Broad Mountain Power

Project

Input to DEP Public Meeting December 4, 2019
Stephen J. Daderko, PE

Attachment 2

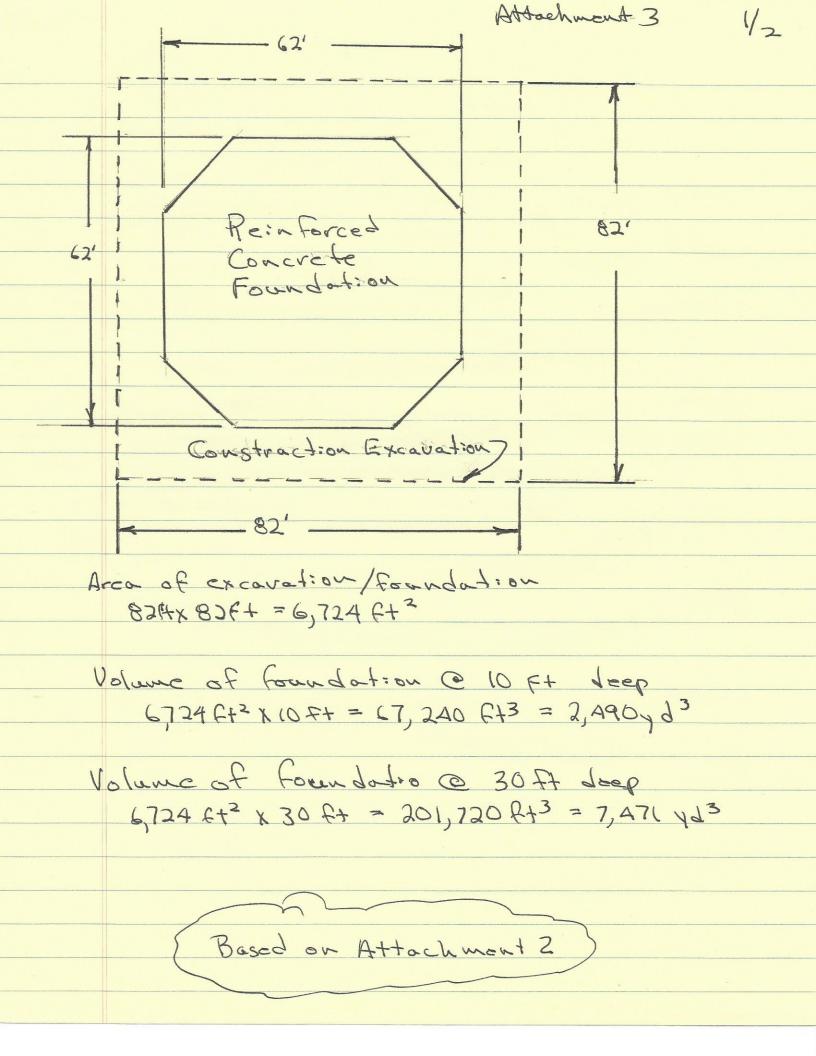
Assuming ground water 5F+ BGL

Volume of water @ 10ft deep foundation 6,724ft2 x 5ft = 33,620 ft3 = 251,478 gal 1ft3 = 7.48 gal

Volume of water @ 30Ft deep foundation 6,724 ft2 x 25 ft=168, 100 ft3=1,257,388 gal

Based on "static" analysis. Excavate hole,
fills to 5ft BGL with no refill.

Actual situation will be pump throughout
excavation and continuing pumping
until removal of forms. Likely
much more significant than "static"
analysis
